our reference: 22000129-R-02
your reference:

14 June 2022

Review of Surface and Ground Water Quality: Windsor Bridge

Figure 4: Plot of pH at the north bank locations, post construction phase.

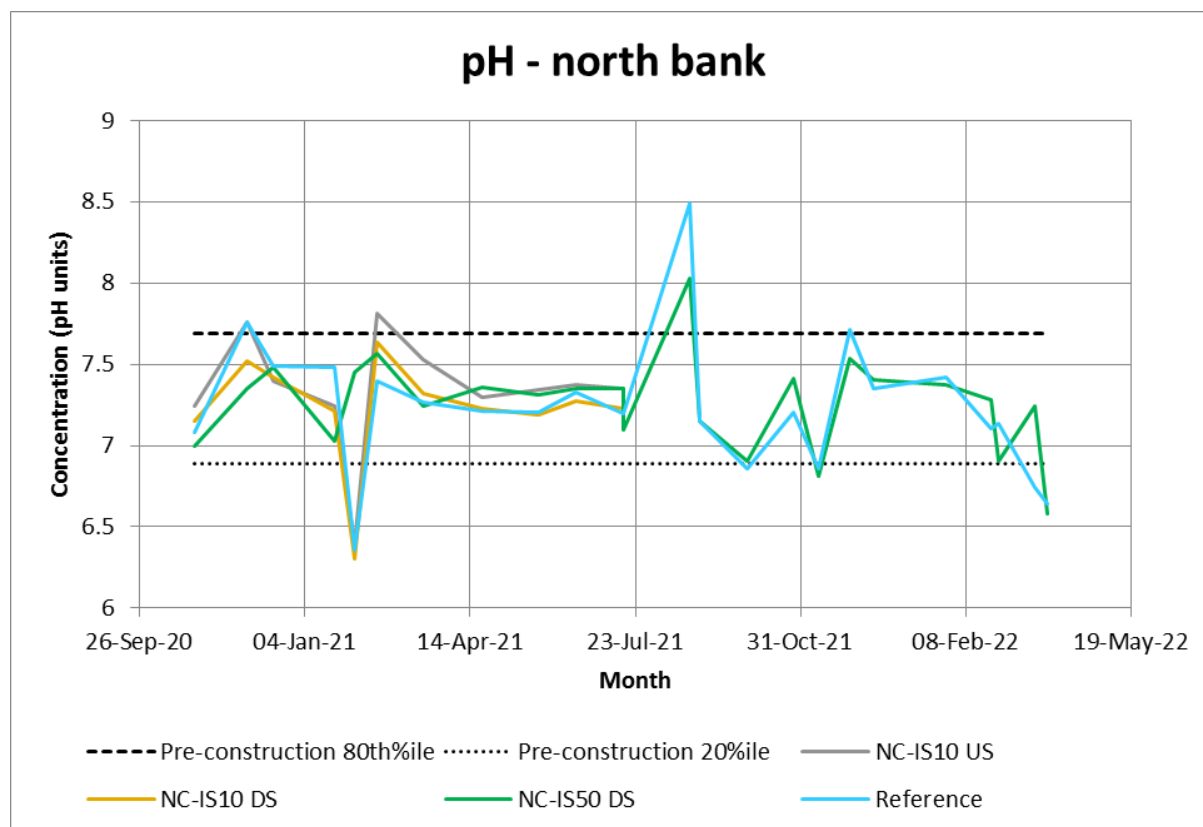
Based on the data in Figure 4, pH is generally within the pre-construction SSTVs and within the ANZECC guideline values (8.5-6.5) except for 6.39 on 3 February 2021 and 6.29 on 22 March 2022, both of which were wet days. pH also decreased at the upstream reference site indicating that the variation was unlikely to be due to the Windsor Bridge project.

Figure 7: Plot of Turbidity at the south bank locations, post construction.

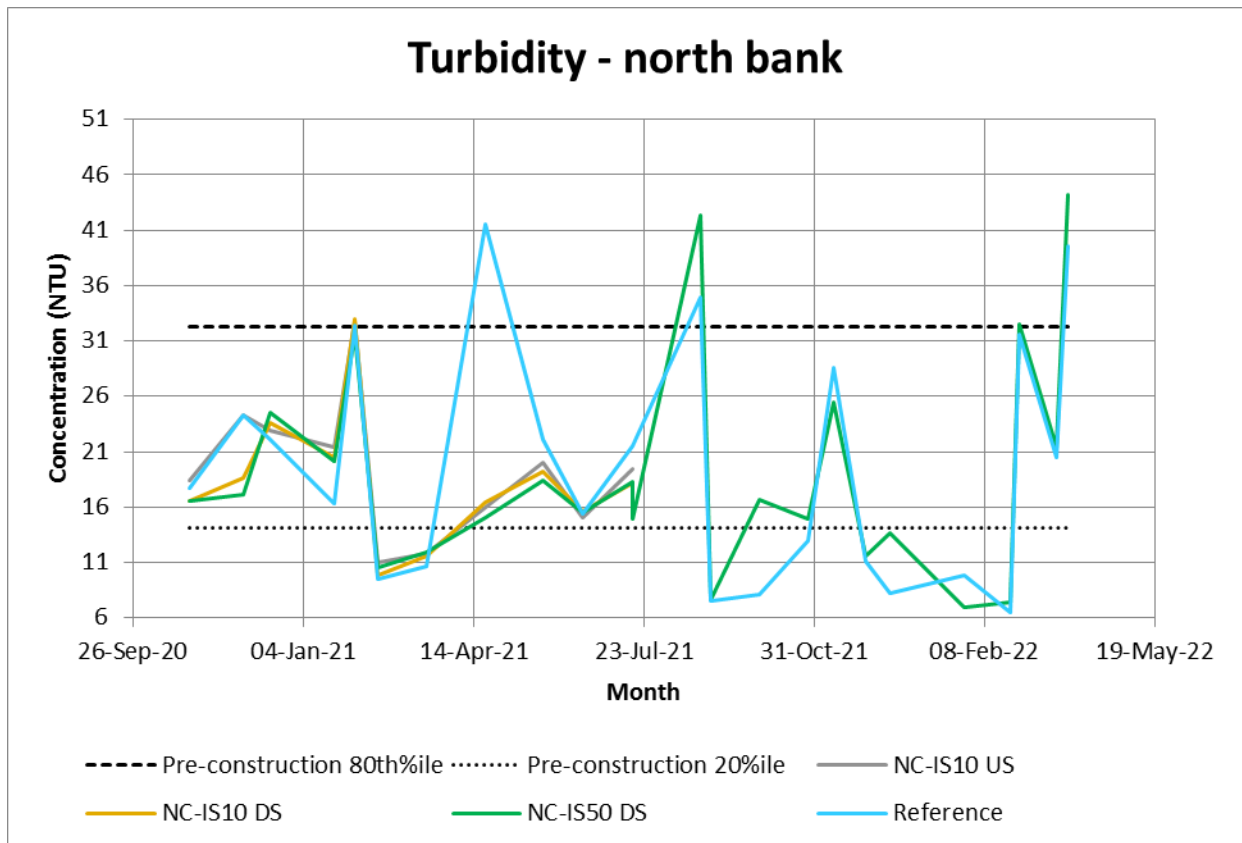
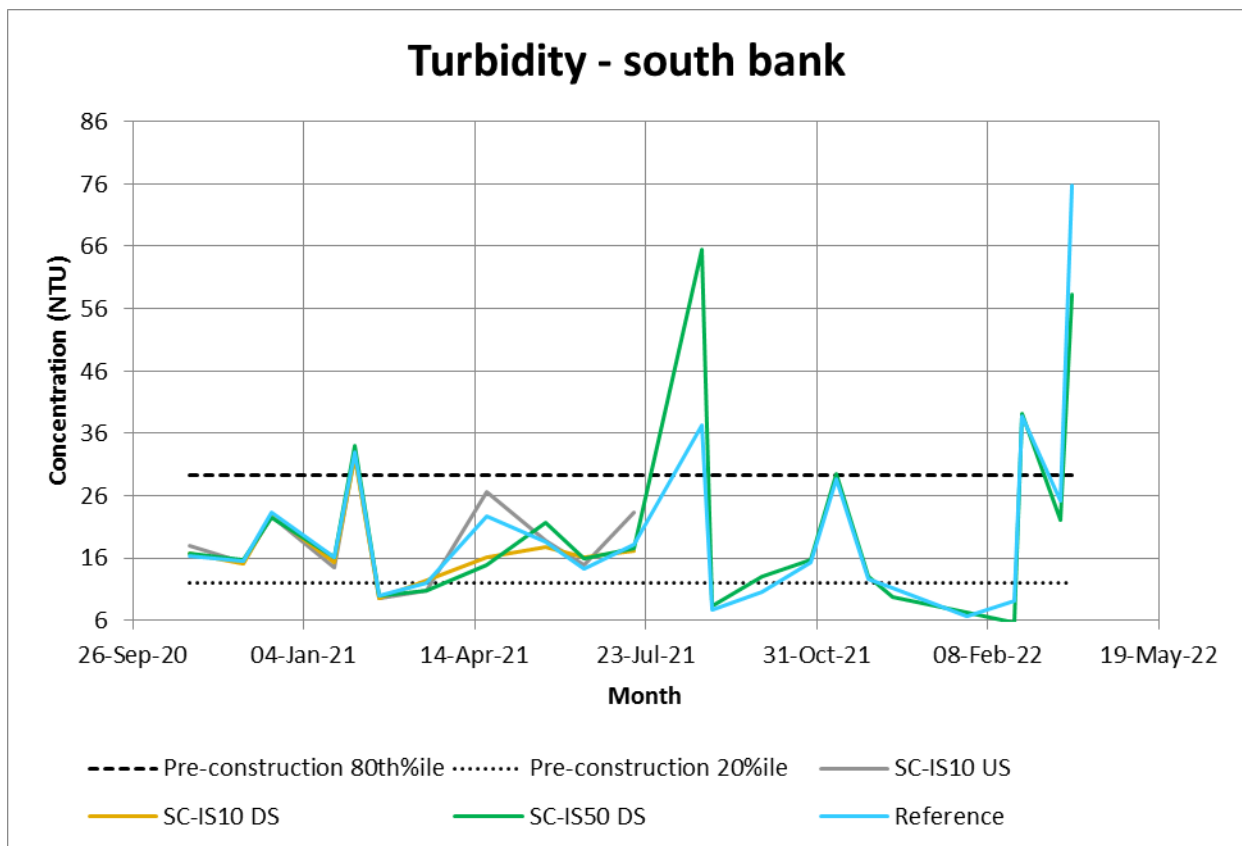
Turbidity was generally within the SSTVs and was lower than the ANZECC guideline value of 50 NTU. Turbidity only exceeded the SSTVs following rainfall and matched the change in turbidity observed at the upstream reference site.

The south bank impact site 50m downstream of the bridge had two instances where turbidity exceeded the ANZECC trigger value. Both were following significant rainfall events in August 2021 and March 2022. The downstream turbidity during the August event exceeded the upstream reference site turbidity however the March event did not. This increase could have been due to exposed soil at the project site however given the possibility that turbidity could have been derived from surrounding agricultural lands, it is not possible to confirm this. Furthermore and as noted above, this anomaly was not repeated during the March 2022 wet weather event.

Several other high rainfall events occurred after the August 2021 round of monitoring, and the turbidity at the project impact site was consistently less than the reference site. This indicates that, if the August 2021 increase was due to construction activities, it had been resolved, possibly by the completion of works and the application of ground cover to limit erosion.

Figure 8: Plot of Dissolved Oxygen at the north bank locations, post construction.

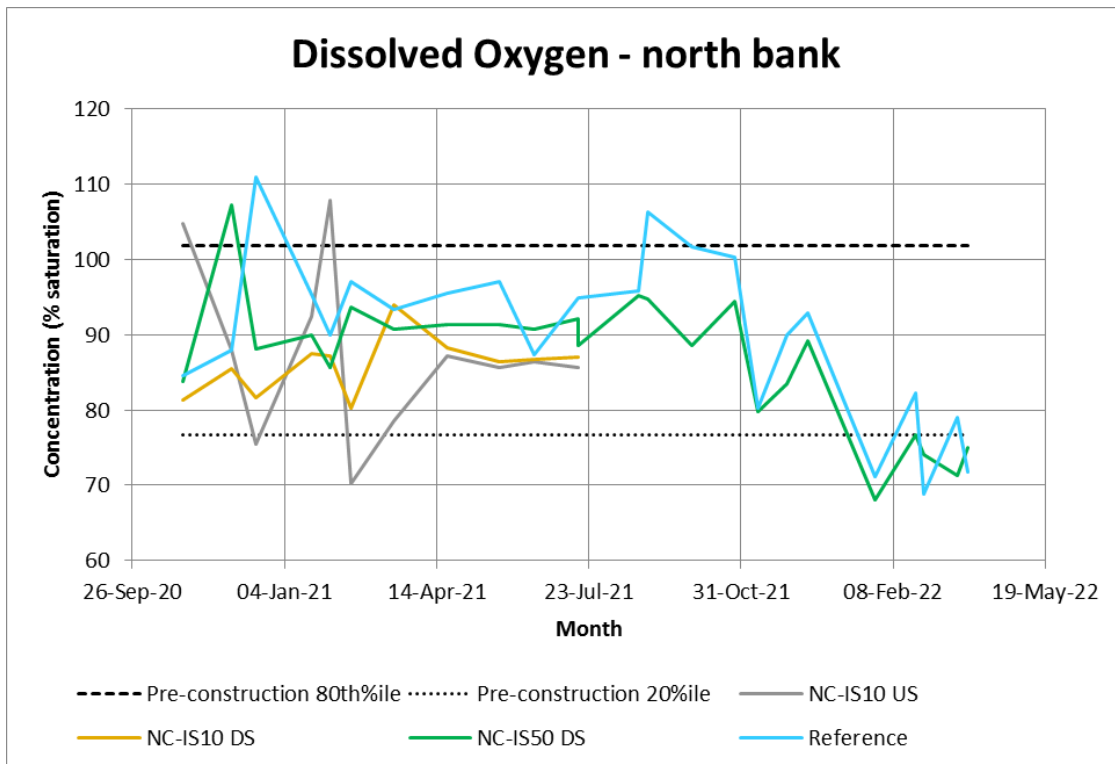
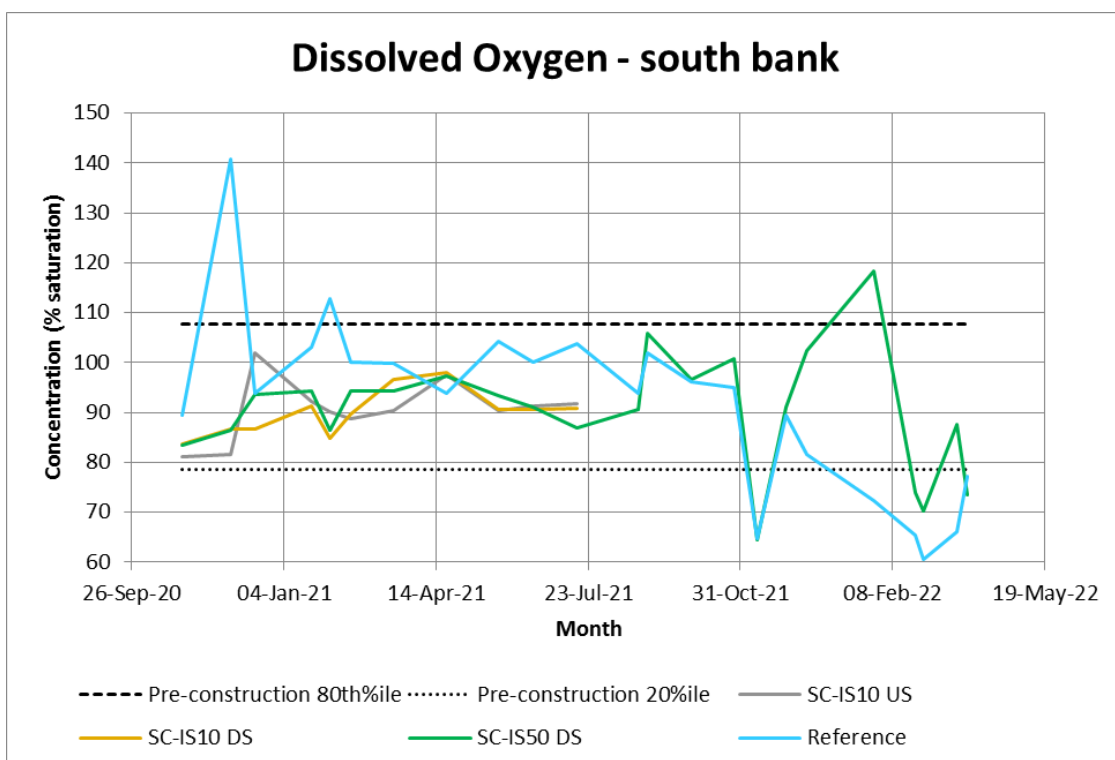
Dissolved oxygen was generally within the SSTVs. Values dropped below the SSTVs at the north bank between February and March however this trend also occurred at

the reference site indicating that it is unlikely that the project was the cause for the observed change in dissolved oxygen levels.

Figure 10: Plot of Total Nitrogen concentrations at the north bank locations, post construction.

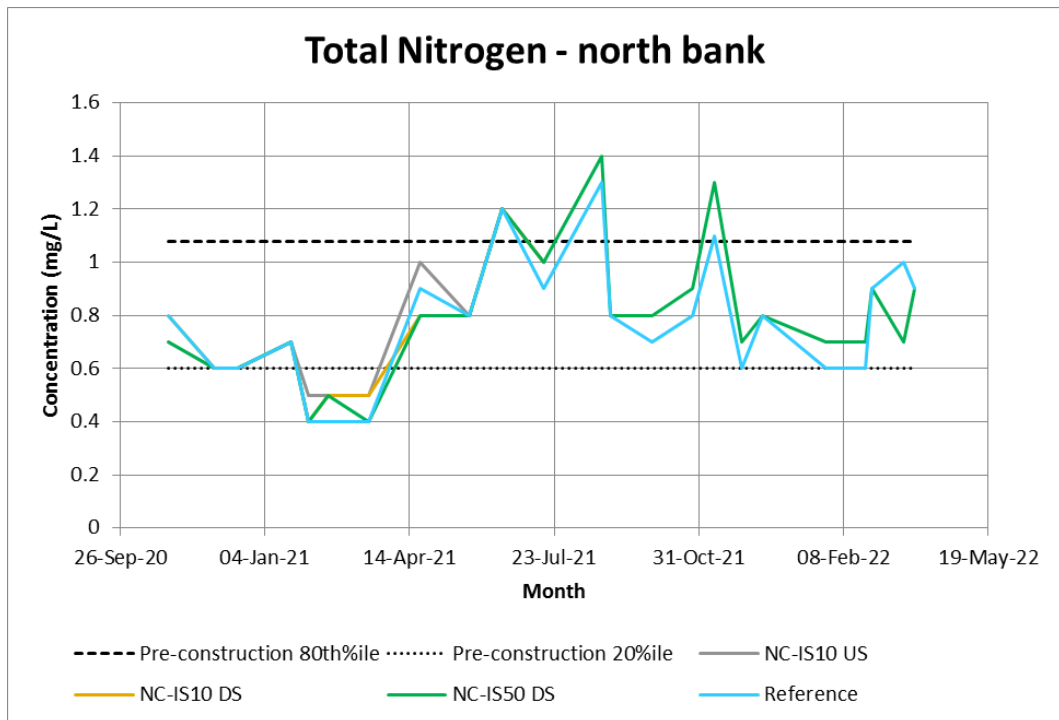
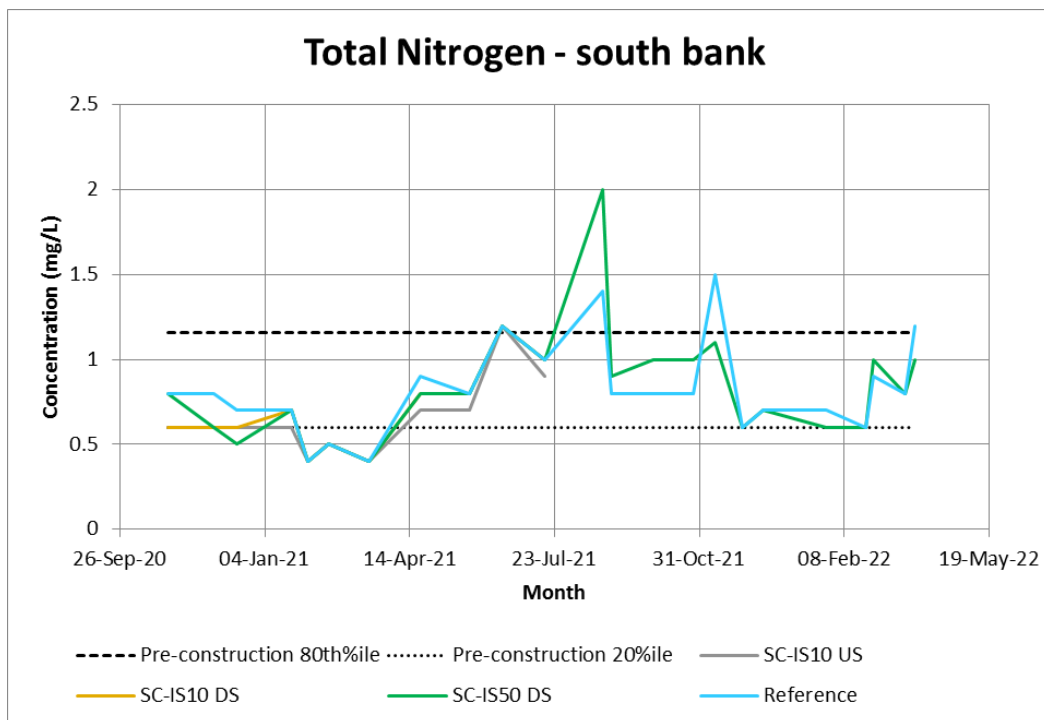
Total nitrogen levels exceeded the ANZECC trigger value of 0.35mg/L but were generally within or below the SSTVs. Observed increases occurred after rainfall events apart from the elevated value observed on 17 June 2021. However this increase also occurred at the reference site indicating that it is unlikely that the

project was the cause for the observed change in nitrogen concentrations. The south bank had a spike on 25 August 2021 following a significant rain event. It is unclear if this was due to the project, and we noted that nitrogen levels were below the reference site for all subsequent rain events.

Figure 12: Plot of Total Phosphorus concentrations at the north bank locations, post construction.

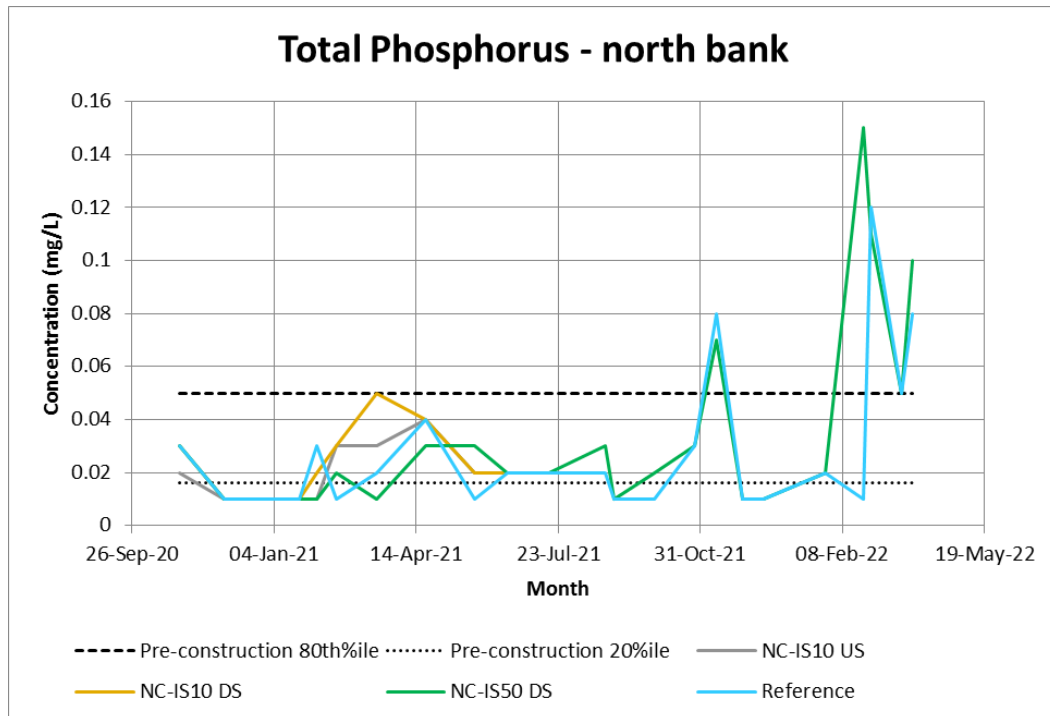
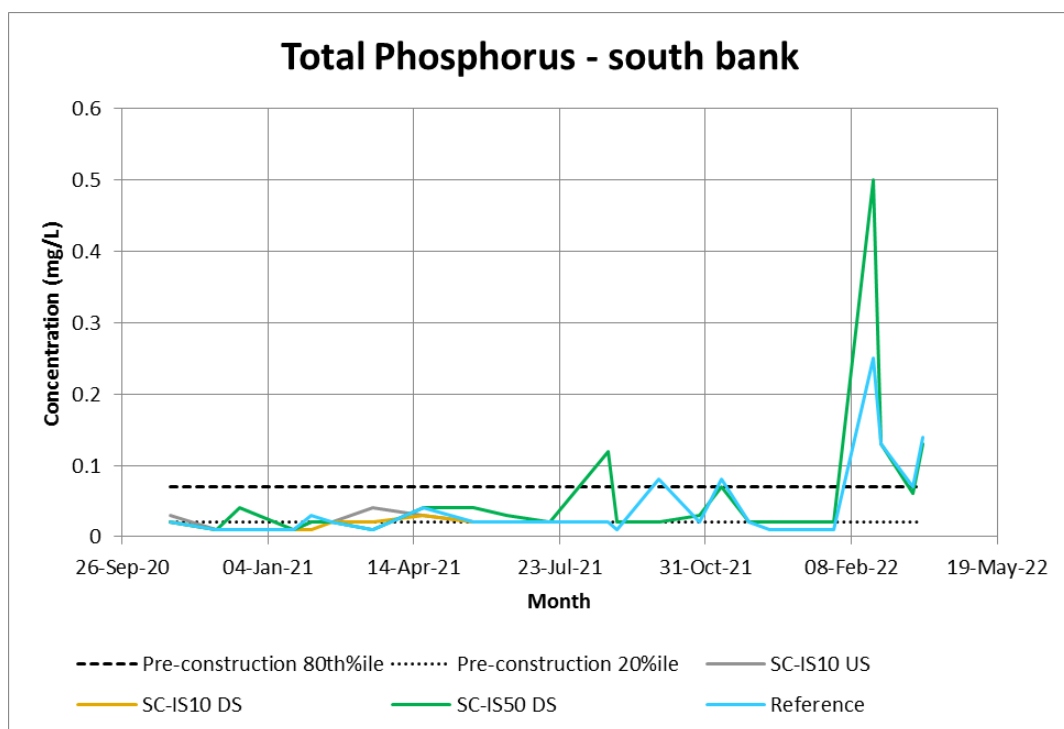
Total phosphorus levels exceeded the ANZECC trigger value of 0.025mg/L several times but were generally within the SSTVs. Observed increases occurred after rainfall at both the impact sites and at the reference site. The spike after the rainfall event on 23 February 2022 exceeded the reference site increase however the recorded value at SC-CS2 (upstream south bank wet weather site) had a Total Phosphorus value of 0.51mg/L which was more than the value recorded downstream. As any increases also occurred upstream or at the reference site it is unlikely that the project caused any change in observed phosphorus concentrations.

Figure 14: Plot of Aluminum concentrations at the north bank locations, post construction.

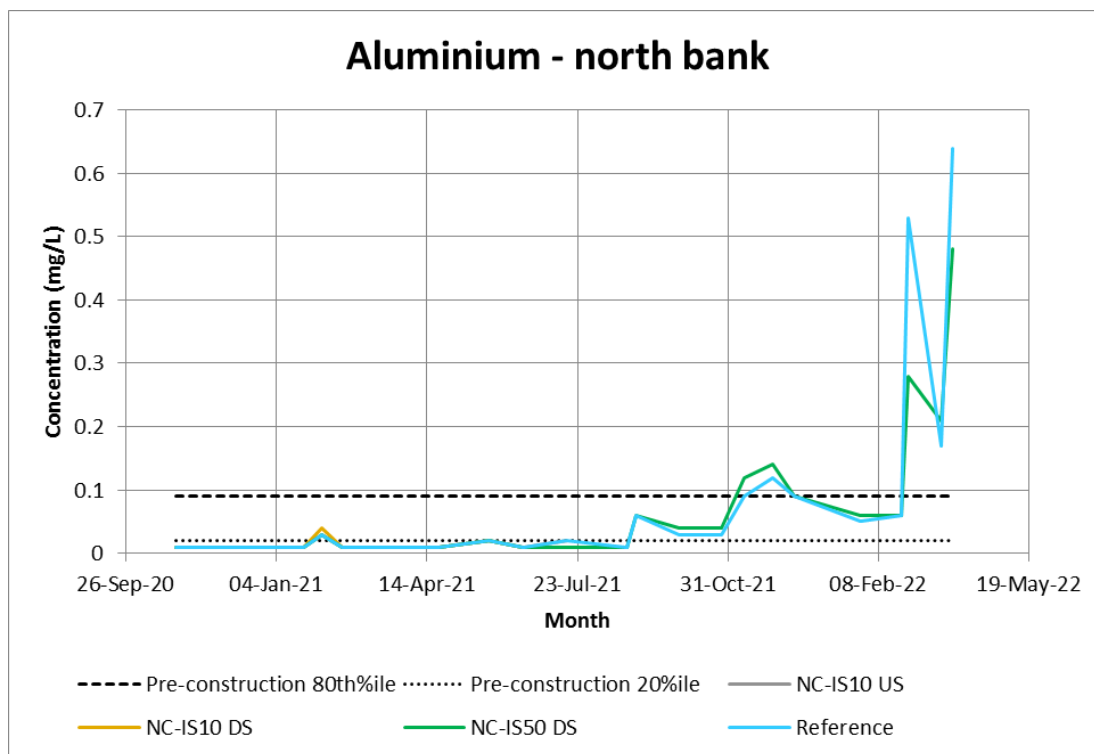
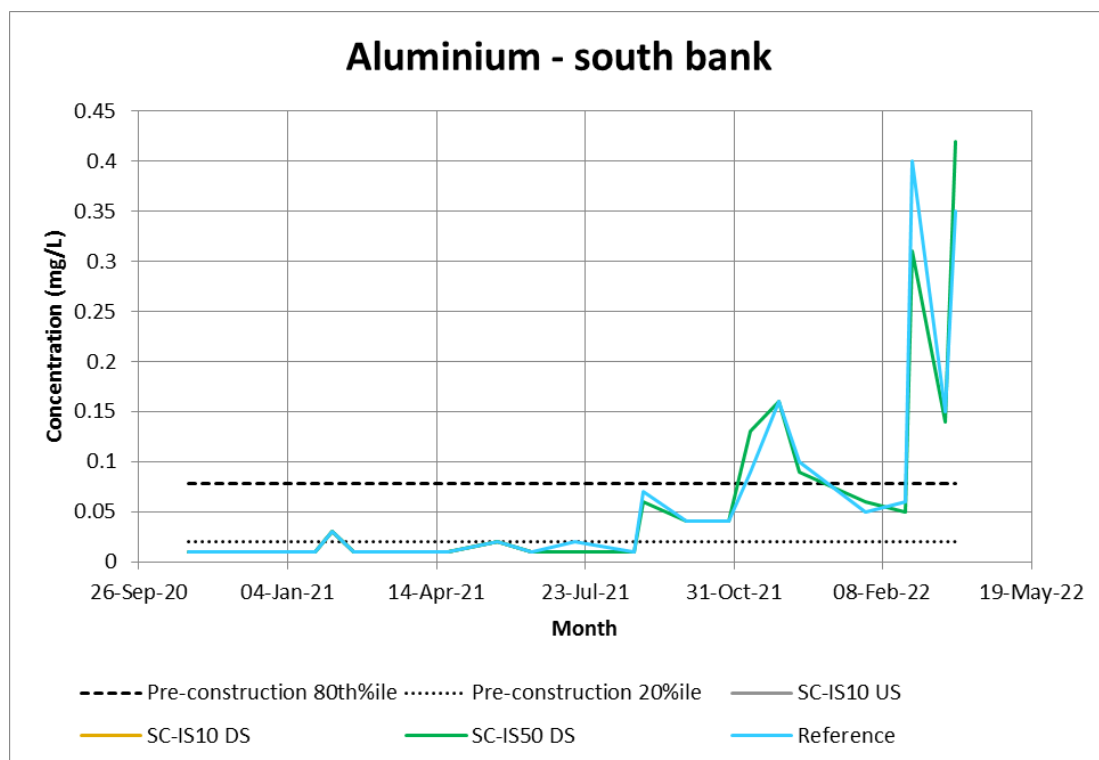
Aluminium levels were below the SSTV and ANZECC trigger value of 0.055mg/L between September 2020 and August 2021 (i.e. during the construction period). However after this date aluminium levels spiked above the SSTV and the ANZECC trigger levels. This increase also occurred at the upstream reference site indicating that it is unlikely that the project was the cause of the observed change in aluminium concentrations.
